SUBARU

SERVICE BULLETIN

NUMBER: 12-96-06

SUBJECT: Rattle/Squeak Noise from
Instrument Panel

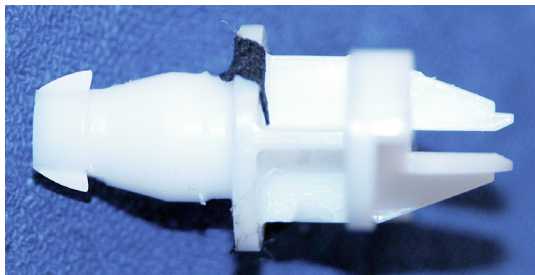
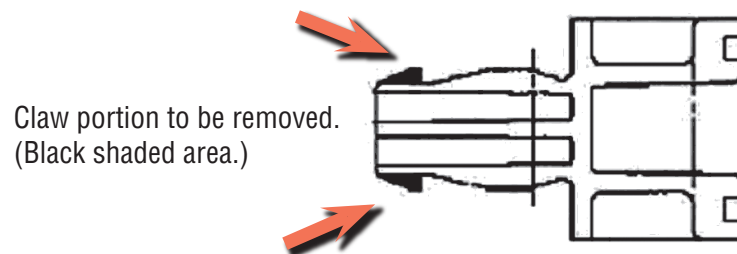
- 2) Inspect the wrapping on the locator pin. If damaged, remove the wrapping and replace it with a piece of non-woven material (12mm wide x 170mm long).

Before Modification

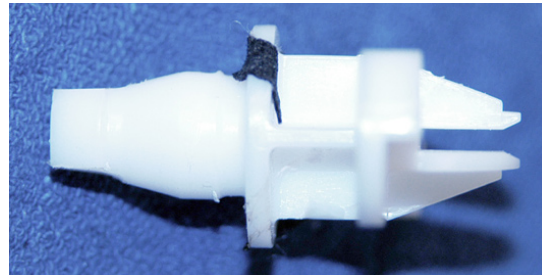
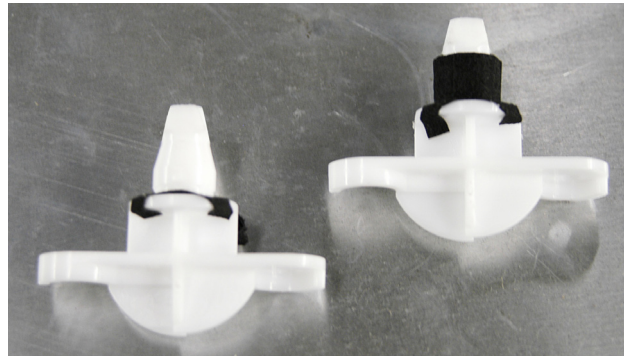
- 3) Remove the left and right hooks which are secured by 2 phillip head screws (2 per hook).
- 4) Carefully remove the claw portion on both hooks. A utility knife, file or die grinder may be used. We suggest using a die grinder. Make sure to wear safety glasses. If using a utility knife, be extremely careful.

Before Wrapping

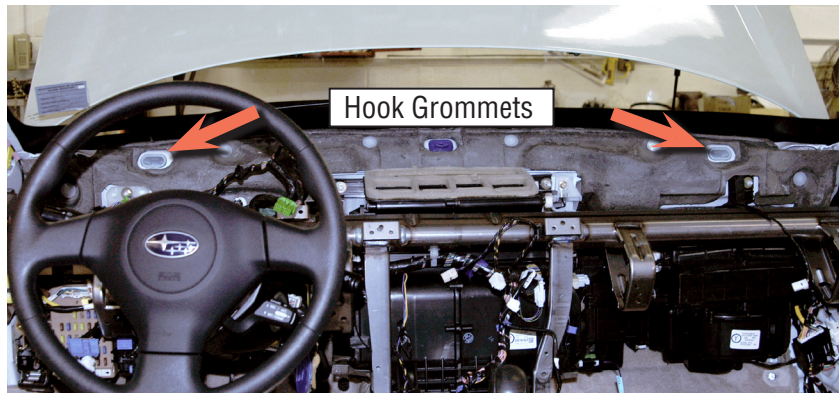
- 5) Wrap each hook with a piece of non-woven material (12mm wide x 110mm long).

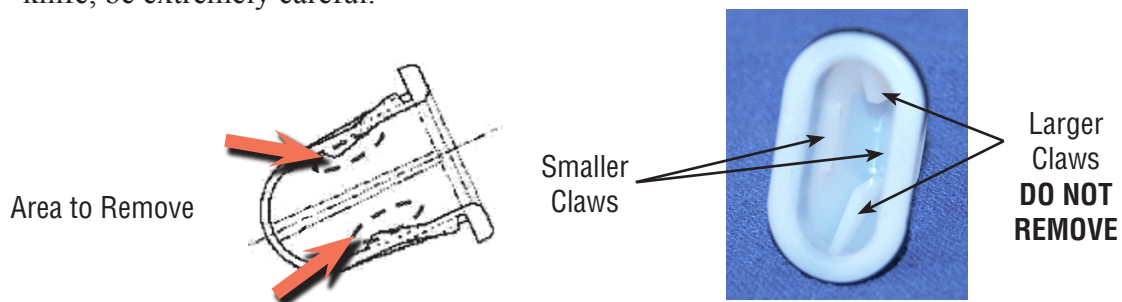
- 6) Reinstall hooks to instrument panel.
- 7) Remove the 2 hook grommets. A small flat head screw driver or a white plastic stick may be used.

- 8) Carefully remove the 2 smaller claws of the grommet. A utility knife, file or die grinder may be used. We suggest a die grinder. Make sure to wear safety glasses. If using a utility knife, be extremely careful.
